# CITY OF ALBUQUERQUE

RE: **Chick-Fil-A @ Coors Pavilion**  
**Coors Pavilion, Lot 6**  
**Conceptual Grading and Drainage Plan**  
**Engineer's Stamp Date: 11/22/17**  
**Drainage File: G11D069C**

Based on the information provided in your submittal received 12/4/17, the Conceptual Grading and Drainage Plan cannot be approved for Site Plan for Building Permit until the following are addressed:

GRADING  
AND  
DRAINAGE  
PLAN

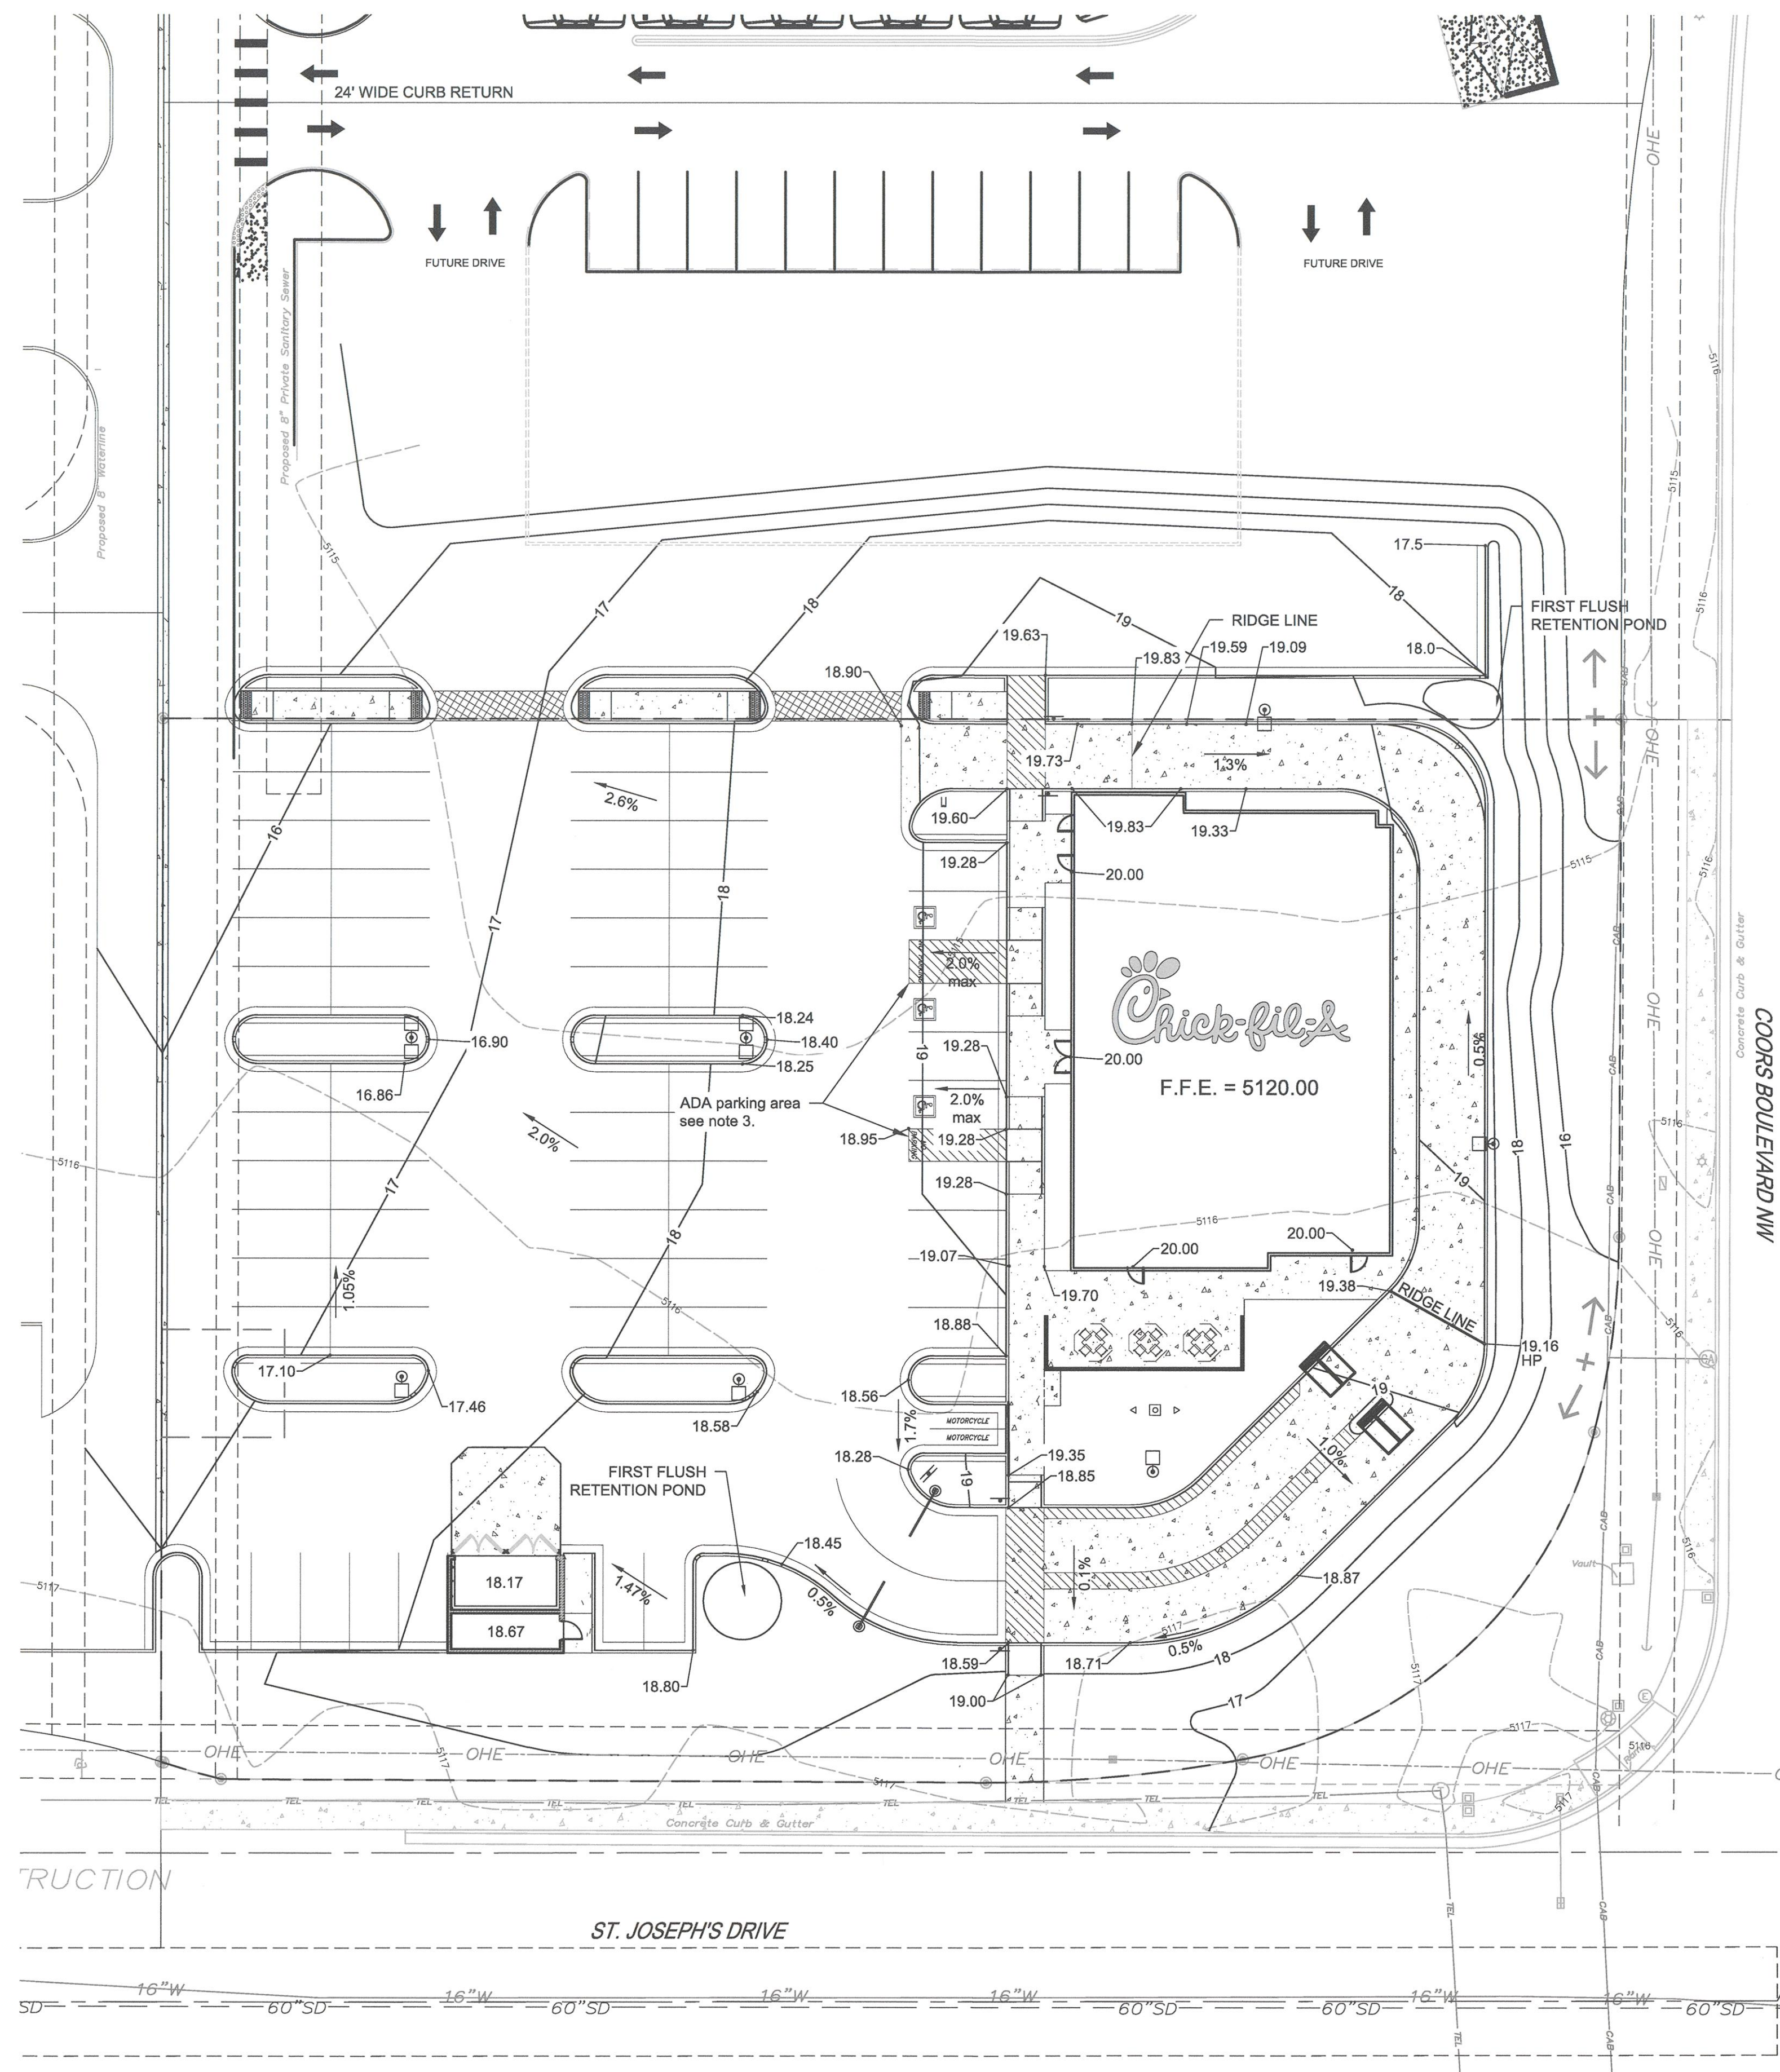
1. Provide a basin map with land treatments, areas, peak runoff, and runoff volume for each subbasin.
2. St. Josephs Drive does not have drainage capacity; no increased runoff to overcapacity systems can be authorized per § 14-5-2-12 (G) of the Albuquerque Code of Ordinances.

3. This plan proposes to discharge a portion of the site to Coors Blvd, an NMDOT road. Written concurrence must be obtained from NMDOT District 3 Drainage that this project can proceed or the. Please contact Tim Trujillo P.E (TimothyR.Trujillo@state.nm.us).

4. If the subbasins draining to the above two roads cannot be rerouted to the subdivision pond or approved by NMDOT (Coors), on-site ponding of the 100-year, 10 volume will be required for these subbasins.

5. Property line and limits of grading do not appear to match the legend. Please verify line-types and update the legend.
6. This project appears to show grading, paving, landscaping, and pond construction across the property line. Written permission must be obtained from the adjoining landowner for this work.

7. For trash enclosures serving food service developments, please include a drain line to a grease trap and then drain into the sanitary sewer. If this information is on the utility plan please provide it, or show on the grading plan.
